FORM APPROVED
OMB NO. 1004-0137
Expires: January 31, 2018**SUNDRY NOTICES AND REPORTS ON WELLS**
*Do not use this form for proposals to drill or to re-enter an abandoned well. Use form 3160-3 (APD) for such proposals.*5. Lease Serial No.
NMNM102036

☒ Oil Well ☐ Gas Well ☐ Other8. Well Name and No.
RDX 15 007

RKI Exploration and Production, LLC is requesting approval to plug and abandon the RDX 15 #007.

RDX Fed #15-7 Plug and Abandon Procedure

**RDX Fed #15-7
Proposed WBD**

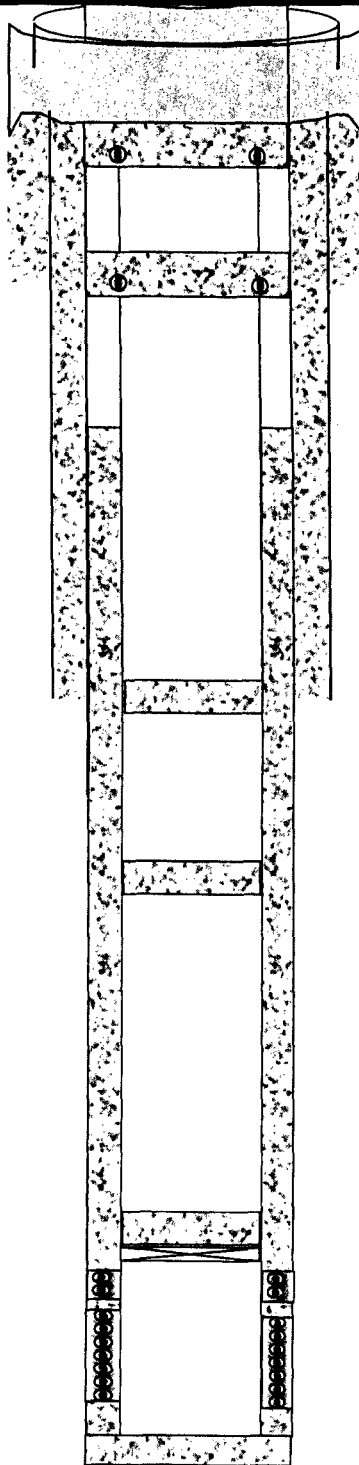
- 7) PU & LD tbg. to 5,065' - Spot 30 sxs from 5,065' - 4,900'.
- 8) PU & LD tbg. to 3,641' - ~~Spot 30 sxs from 3,641' - 3,500'.~~ Perf @ 3641. Attempt to Sgz cmt to 3500. If no Sgz. Spot cmt from 3641 - 3500. WOC Tag
